RE: 211 S. Lamar Blvd. Planned Unit Development Assessment;
Item 91 on Austin City Council's Agenda for December 13, 2012

As owners of Bridges on the Park Condominiums, we write to you regarding the 211 South Lamar Planned Unit Development (PUD), which is located at 211 South Lamar Boulevard and 1211 West Riverside Drive and is within the Town Lake Watershed. This is Item 91 on Council's agenda for December 13, 2012.

3. Land Use Plan Comments – Sheet 1

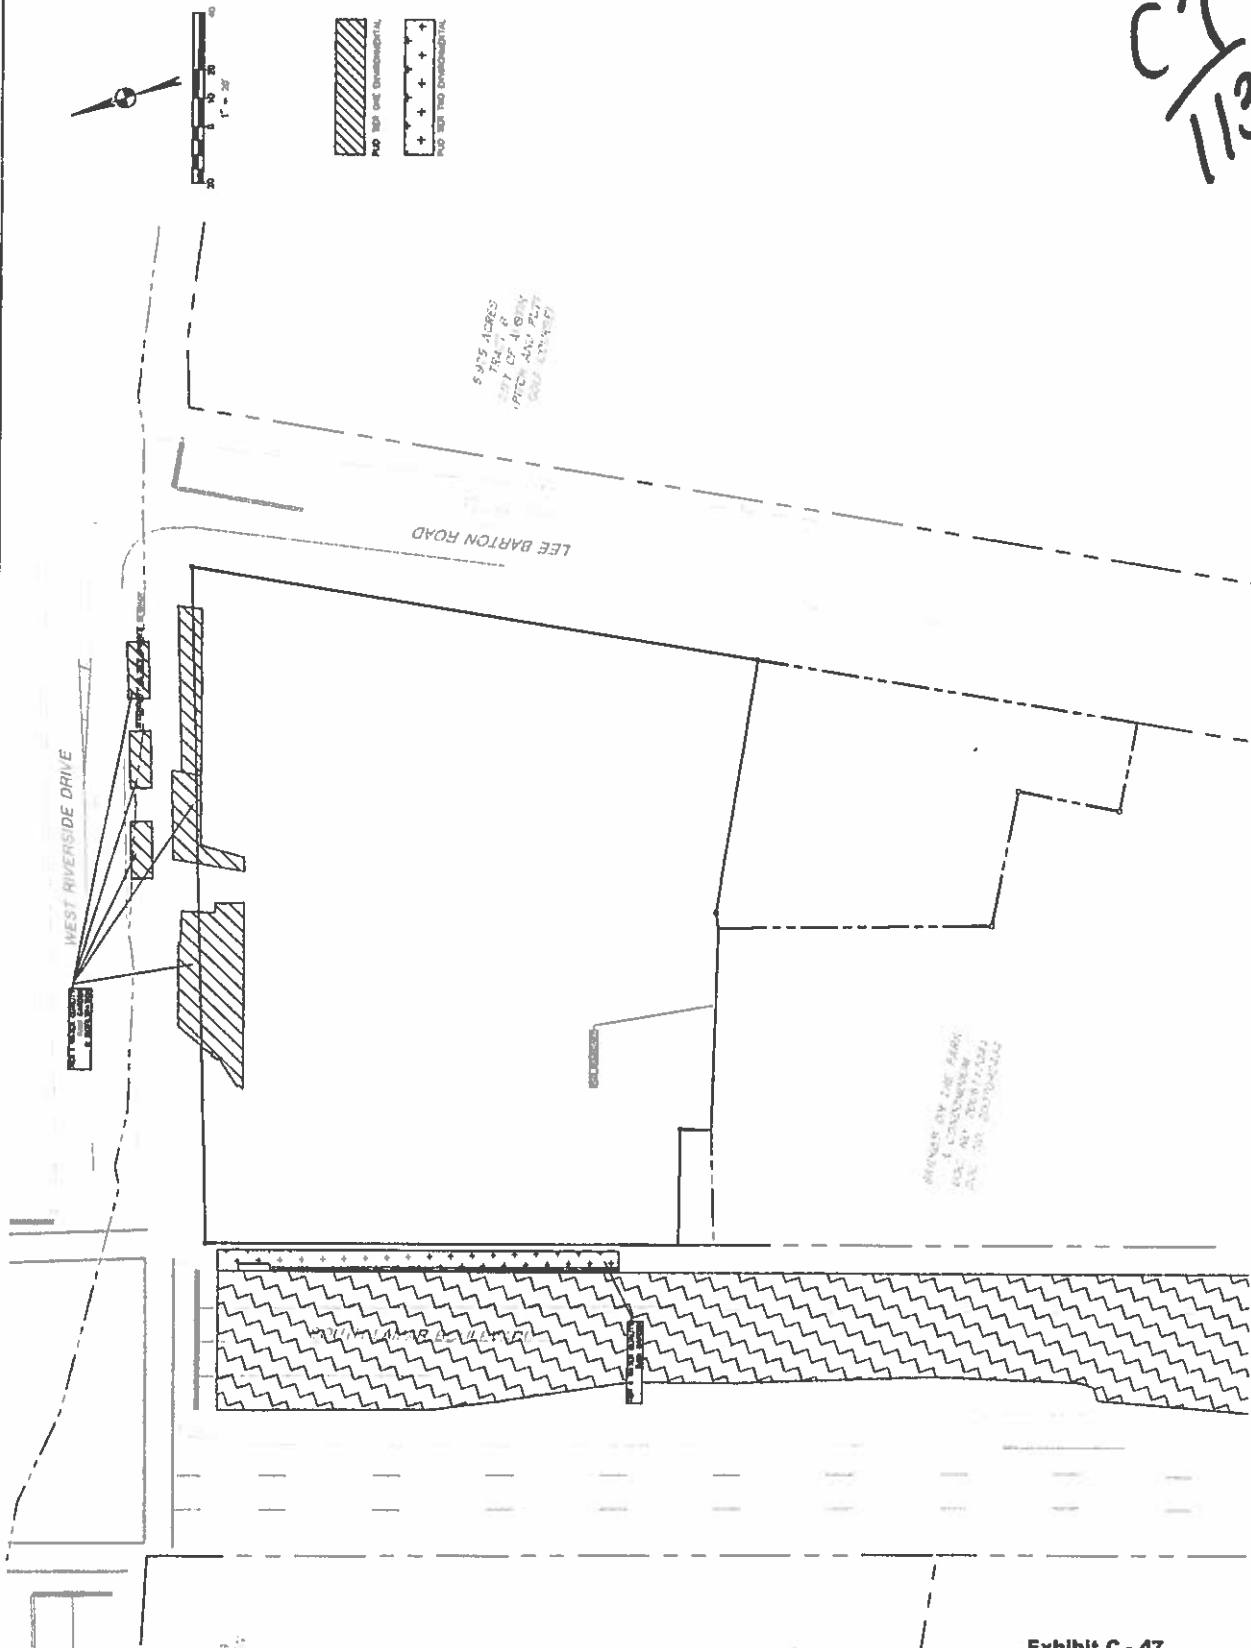
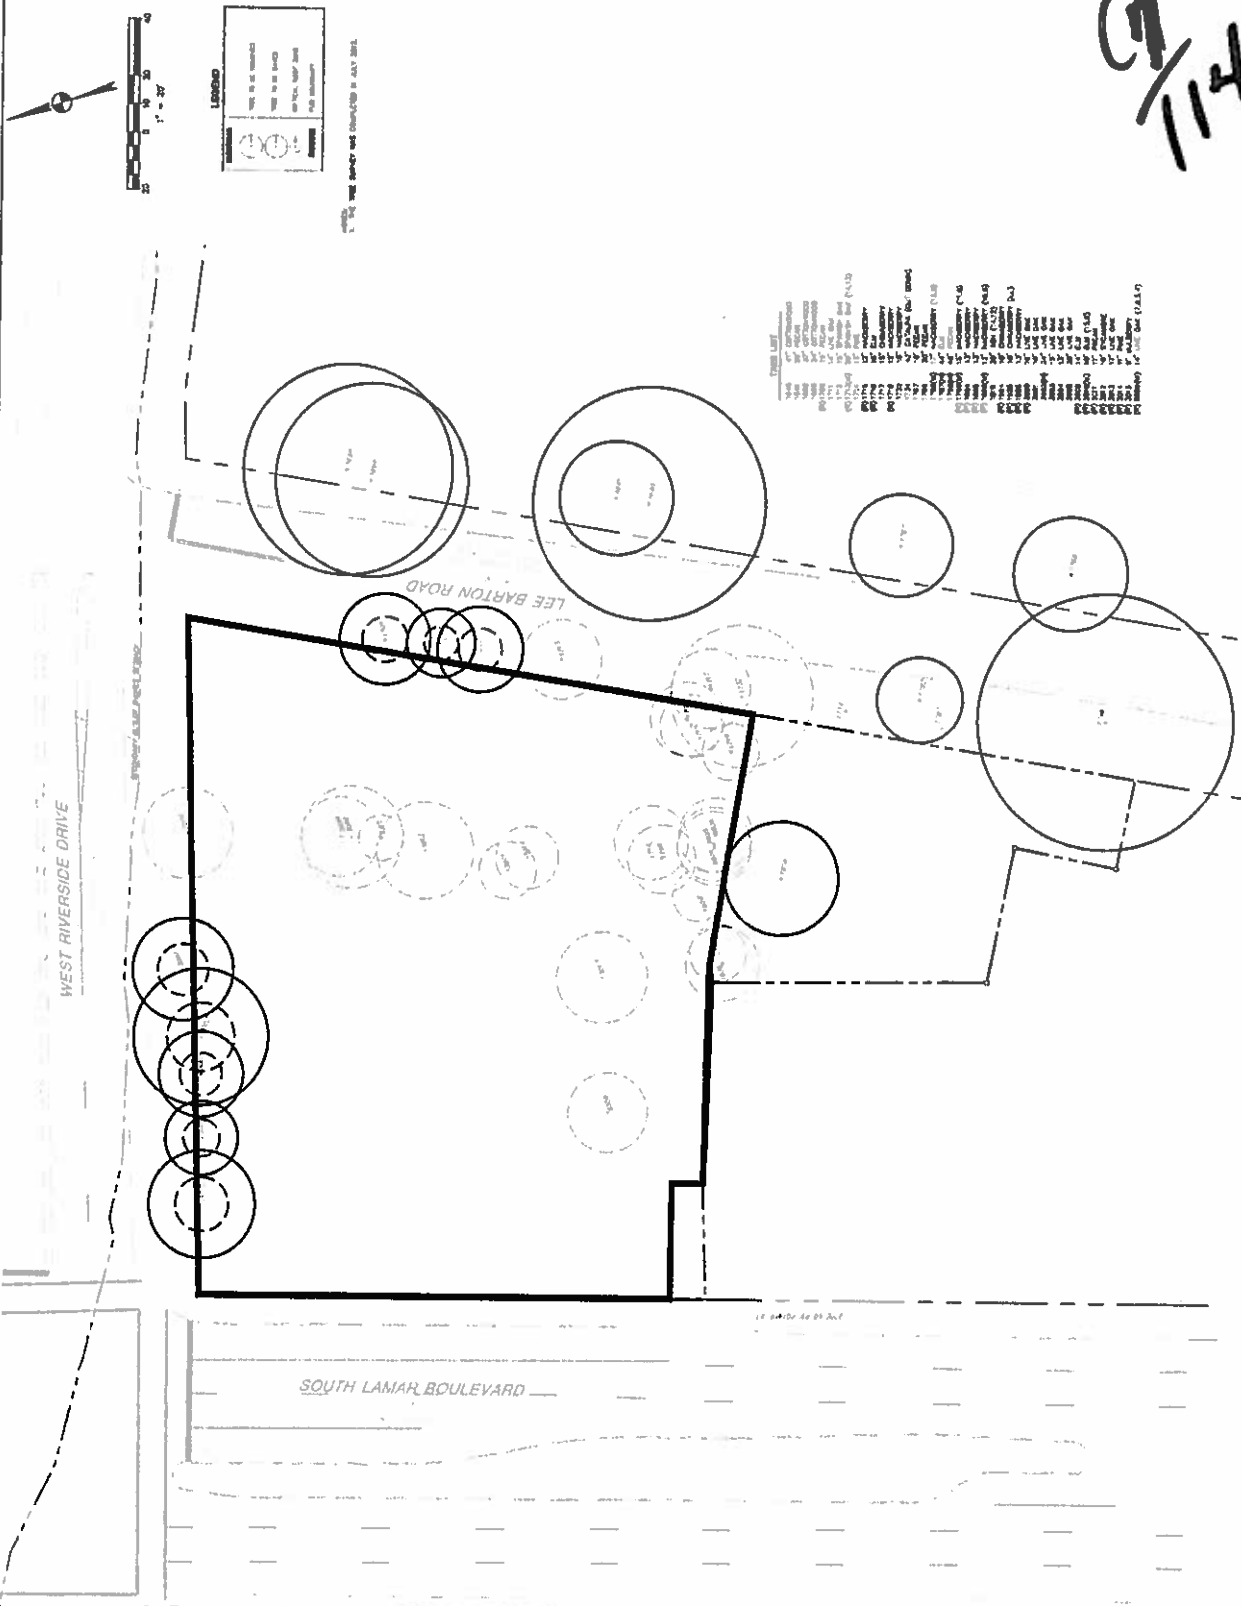
In addition, the developer proposes to add a sidewalk on the portion of Riverside Drive that is adjacent to the northern edge of the Butler Pitch and Putt. It would appear that either the oleander bushes would have to be removed or additional road space would be needed to accommodate this sidewalk. Both of these options are not practical as there isn't sufficient road space and the oleander bushes serve as a natural barrier that protects pedestrians from wayward golf balls from the Butler Pitch and Putt. We ask that City staff maintain the status quo.

OFFSITE
PEDESTRIAN
IMPROVEMENTS

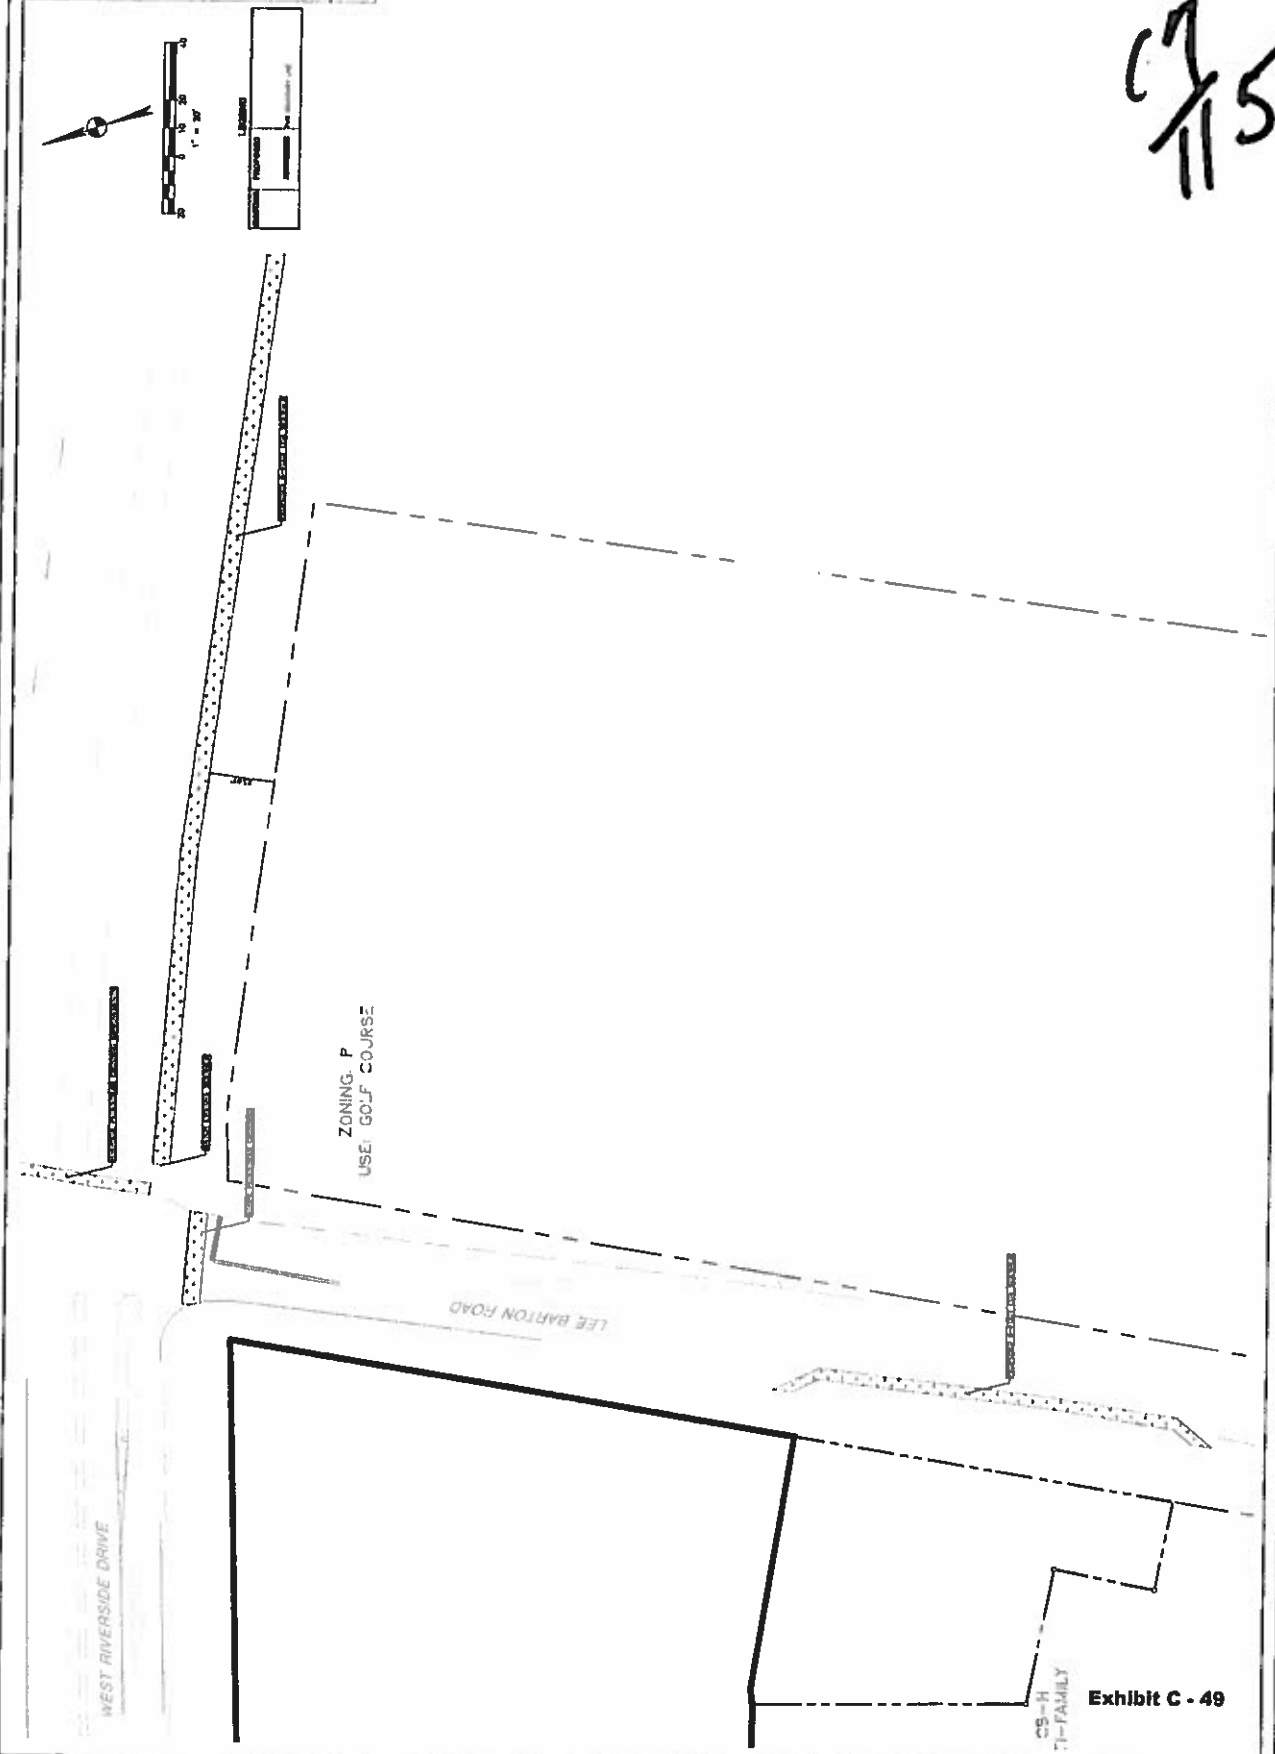
14. Clarify the type of pedestrian cross walk improvements contemplated for crossing of Riverside at Lee Barton. (Winstead)
